**CITY OF FORT COLLINS
TYPE 1 ADMINISTRATIVE HEARING**

FINDINGS AND DECISION

PROJECT NAME: Jerome Street Station

CASE NUMBER: PDP # 210009

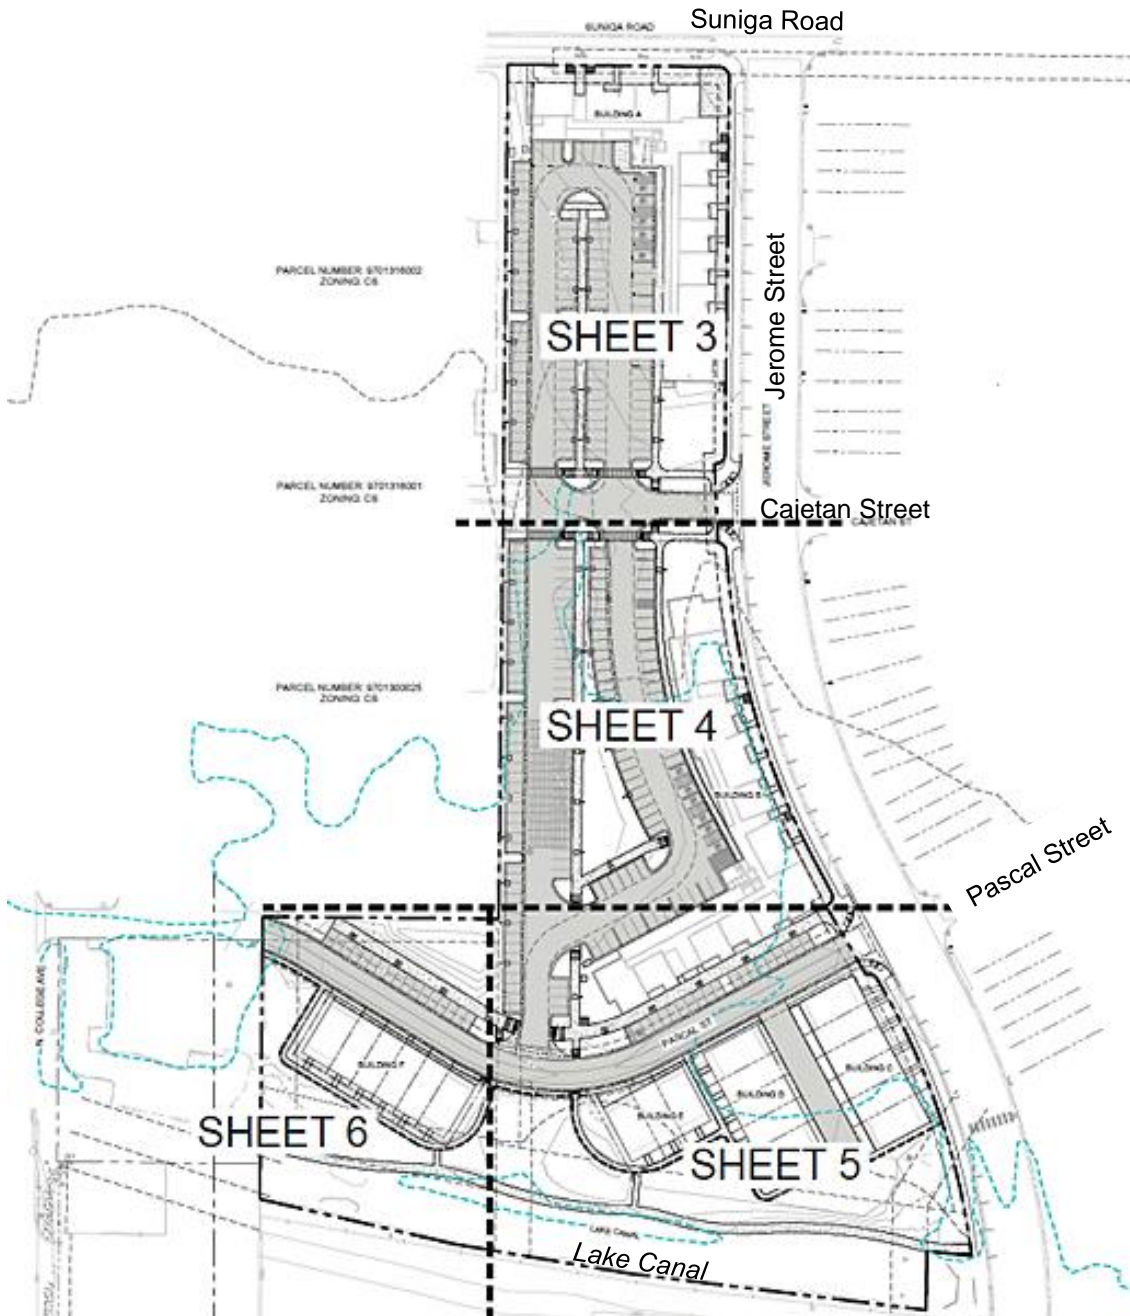
Detriment to the public good

The plan provides a framework of public space with some buildings facing onto walkway spines as an alternative in lieu of streets per se. The framework incorporates and connects to the existing streets. There is no detriment in terms of creating a disconnection in the larger neighborhood pattern. Nor is there a detriment in the larger distances from streets to some of the dwellings because of the formative quality of the spaces and walkways that are provided in lieu of streets.

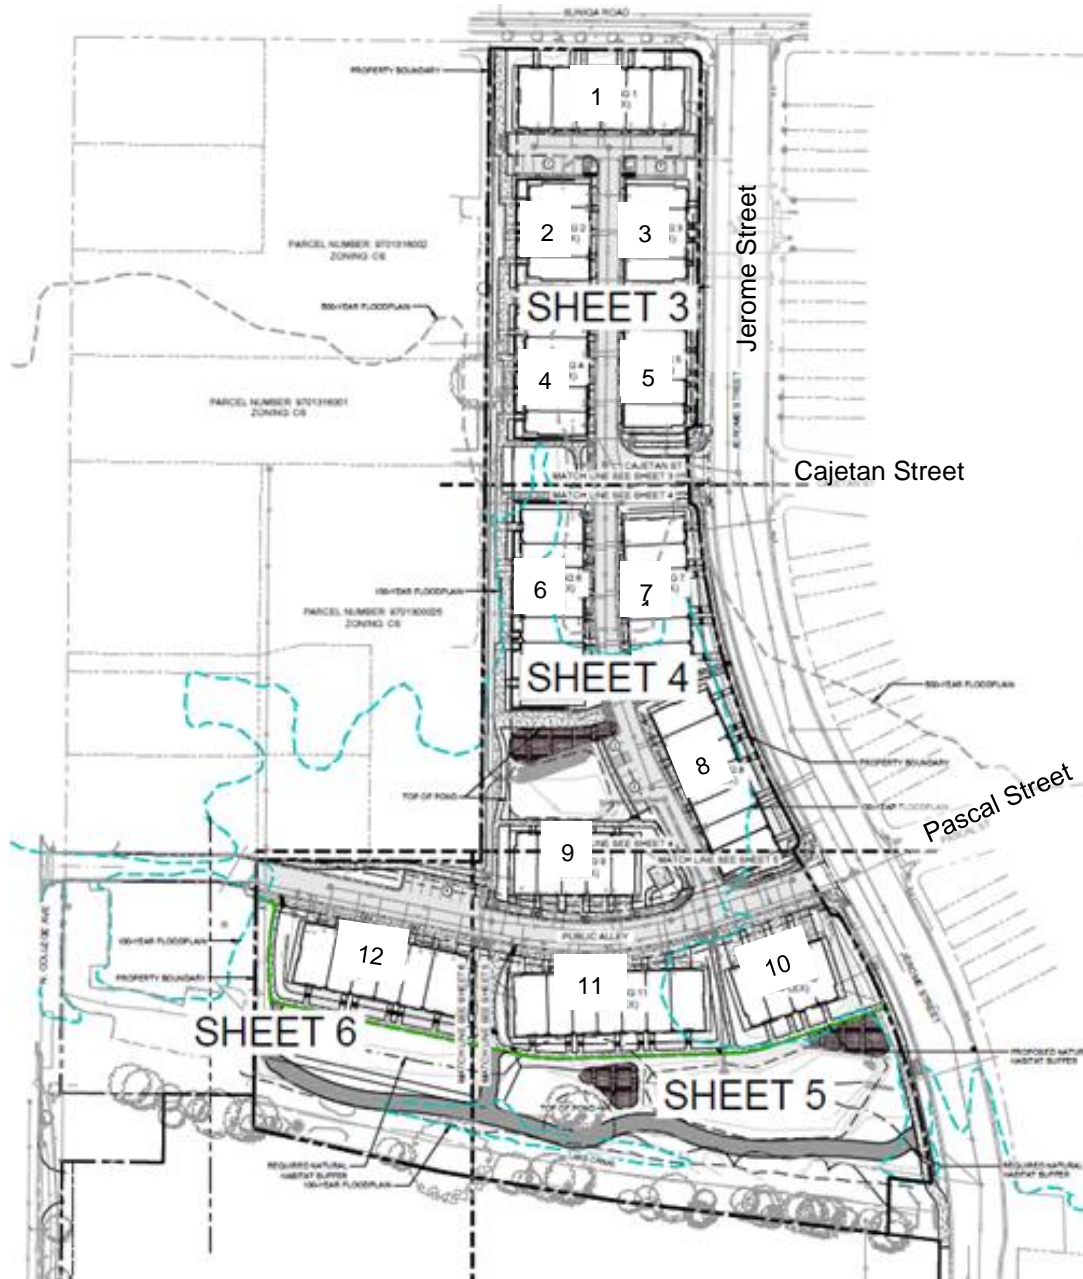
This general overall approach to development was illustrated in an early concept plan:

This plan illustrates a concept for 4- and 5-story condominium development, which did not proceed. As a minor note, the southwestern building would need a modification for garages on Pascal.

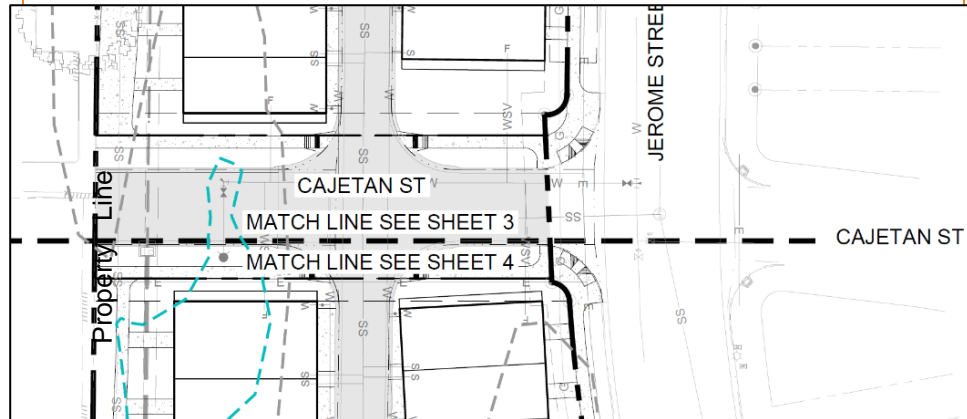
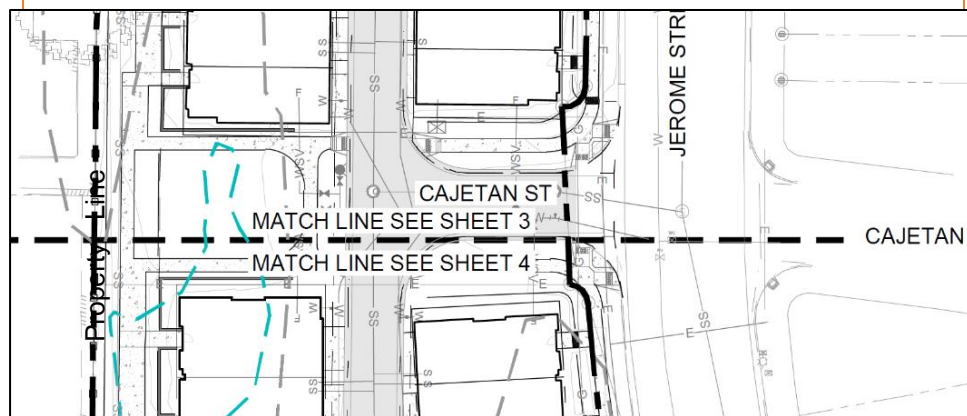
Cajetan Street. The first plan submittals showed Cajetan Street extended and stubbed to the west property line – shown below as background information.

Staff and the applicants explored the implications of building this street, now and in the future. The likelihood of and implications for potential redevelopment to the west was a consideration along with traffic operations if such a street were ever to connect to North College.

Such a street would require total redevelopment of two or more properties on the west. The street would not be needed for functionality of vehicular traffic operations given the proximity of Suniga Road 350 feet to the north.

- The exploration of various alternatives led to the proposed plan which extends the *sidewalks* in an access easement to be stubbed to the property line – shown below. This pedestrian access would be extended through any future redevelopment on abutting property.

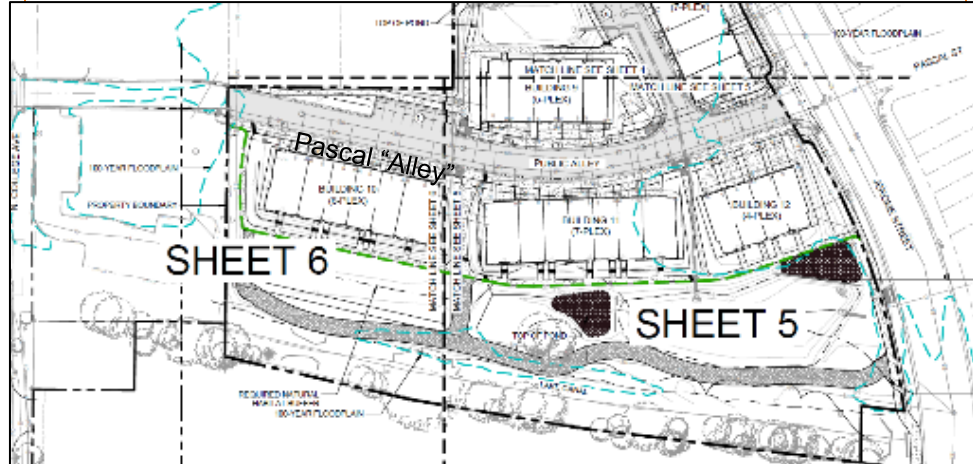
Pascal Street. The question of how to extend Pascal Street was explored along with the Cajetan Street question.

- The resulting alley-like facility is a unique tailored solution that enables connection to North College via an existing access easement on the west. The blurry image below indicates the general arrangement which is shown clearly on the attached plans.
